**SUBJECT:** **NEW VEHICLE DEMONSTRATION / DELIVERY HOLD - Safety Recall 17S08**  
Certain 2017 Model Year F-450/F-550 4X4 Vehicles with 205" Wheel Base and  
4.88 Axle Ratio  
Three-Piece Driveshaft Conversion

**NEW VEHICLE DEMONSTRATION / DELIVERY HOLD - Safety Recall 17S08**

FIGURE 1

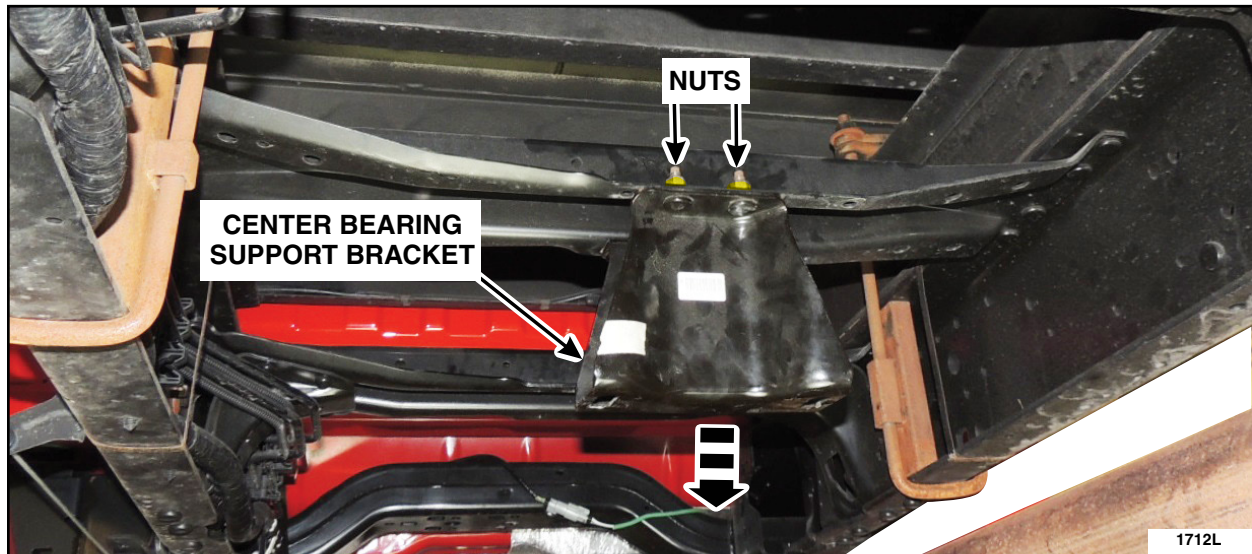
1. Remove the two-piece rear driveshaft. Please follow the Workshop Manual (WSM) procedures in Section 205-01.
2. Remove and discard the original center bearing support bracket. See Figure 1.

**FIGURE 2**

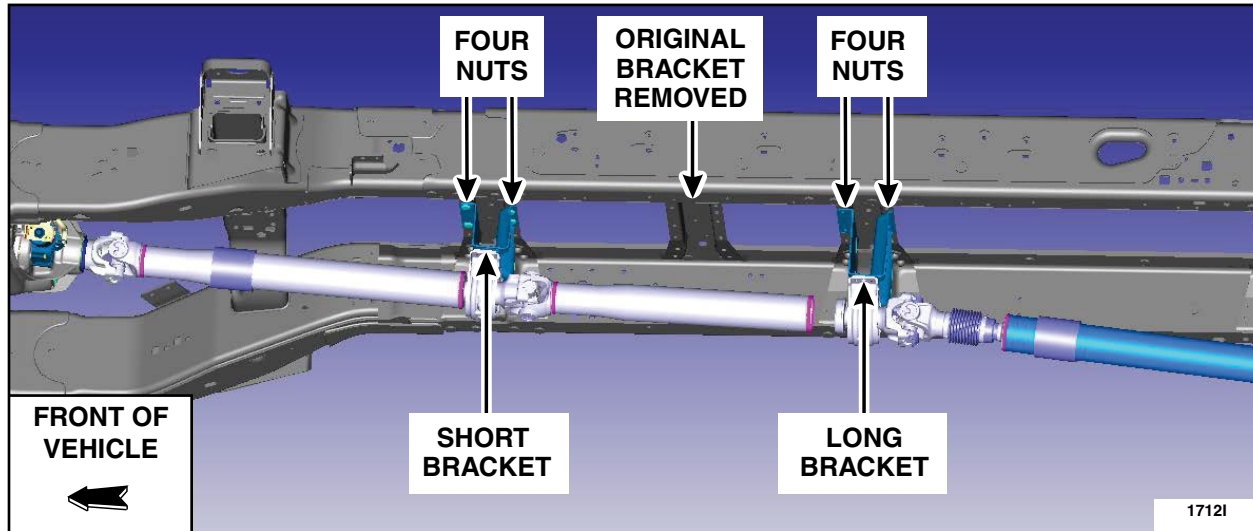
3. Install the two *new* driveshaft bearing support brackets and eight *new* driveshaft bearing support bracket attaching nuts (four on each bracket). See Figure 2.

- Tighten nuts to 23 Nm (17 lb-ft).

**FIGURE 3**

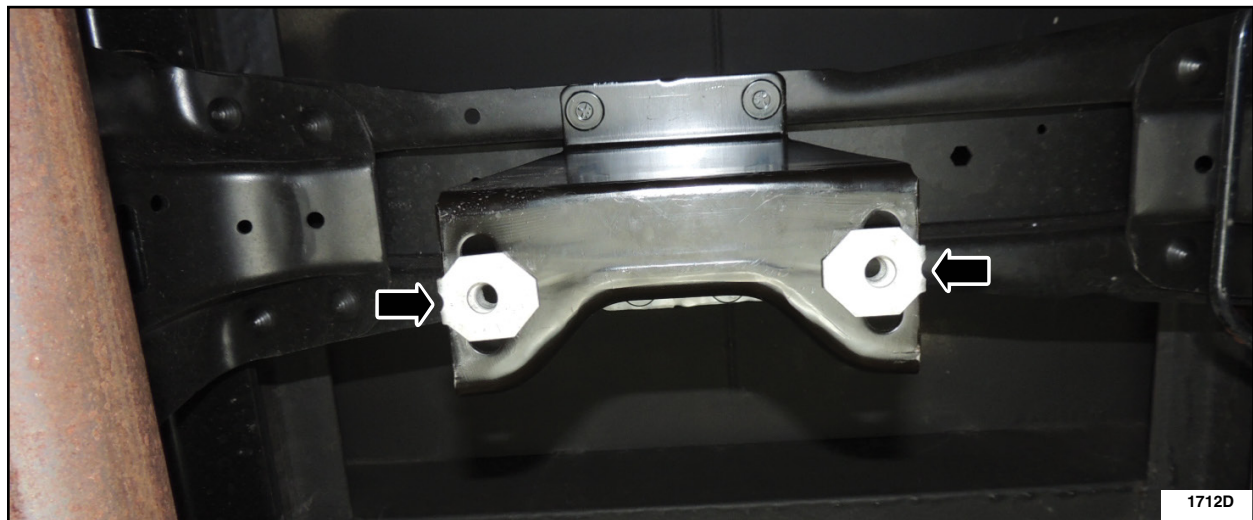
4. Install two *new* driveshaft bearing support spring nuts to both *new* driveshaft bearing support brackets. See Figure 3.

**FIGURE 4**

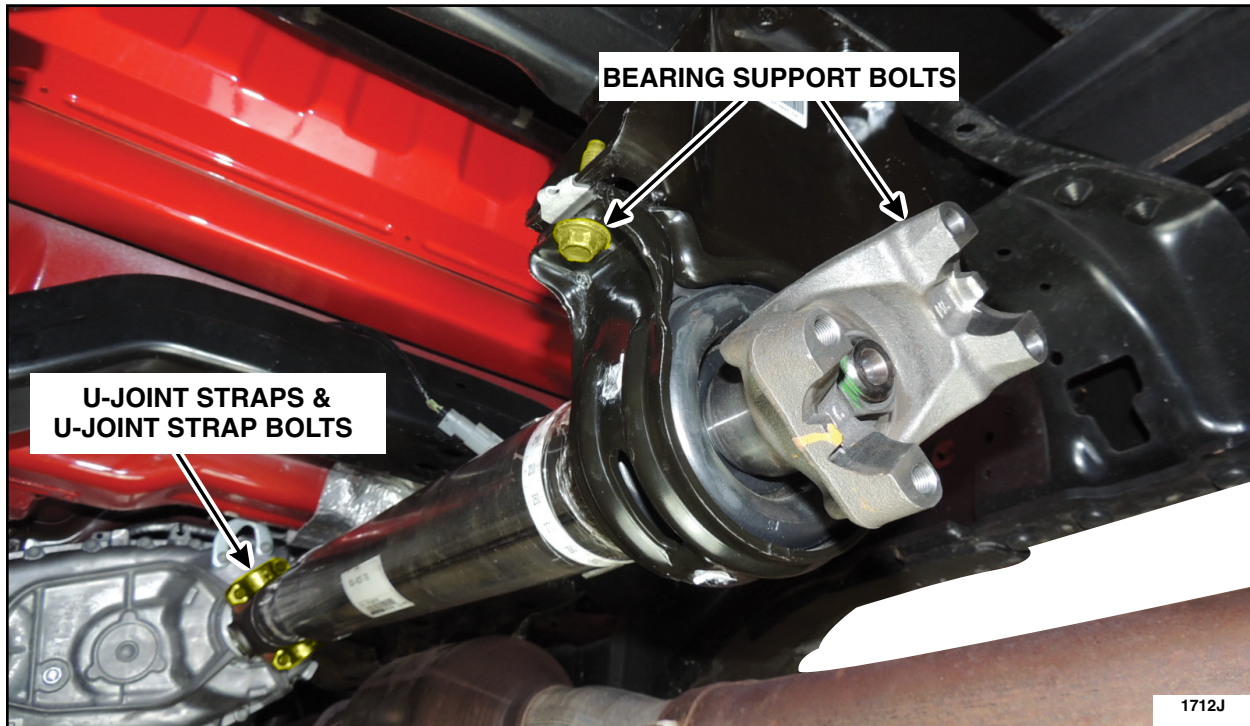
5. Install the front section of the driveshaft. See Figure 4.

- a. Install the two *new* driveshaft front bearing support bolts.
- b. Install the two *new* U-joint straps.
- c. Install the four *new* U-joint strap bolts.

- Do not fully tighten the front bearing support bolts U-joint strap bolts at this time.

7. Tighten the twelve U-joint bearing strap bolts (front, center, and rear) to 63 Nm (46 lb-ft). See Figures 4 and 5.
8. Verify the bearing support bolts are in the middle to mid-front of the bearing support bracket slots, and the bearing supports are perpendicular to the center line of the driveshaft.
9. Tighten the four bearing support bolts (two on each driveshaft bearing support bracket) to 70 Nm (52 lb-ft). See Figures 4 and 5.

**FIGURE 5**

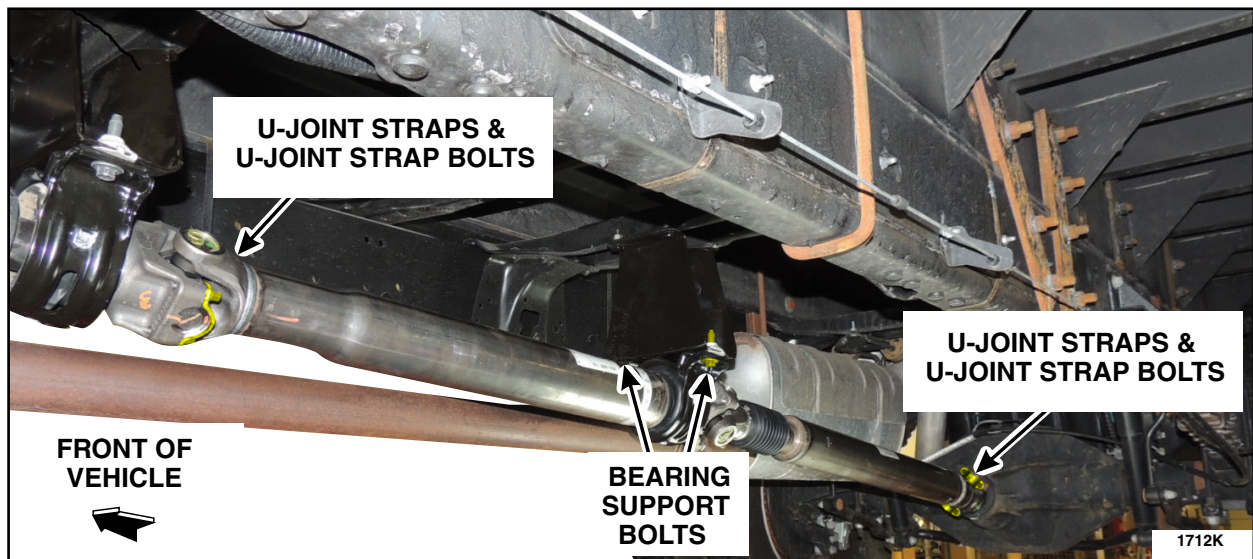
6. Install the rear two sections of the driveshaft. See Figure 5.

- a. Install the two *new* driveshaft rear bearing support bolts.
- b. Install the four *new* U-joint straps.
- c. Install the eight *new* U-joint strap bolts.

- Do not fully tighten the rear bearing support bolts and U-joint strap bolts at this time.
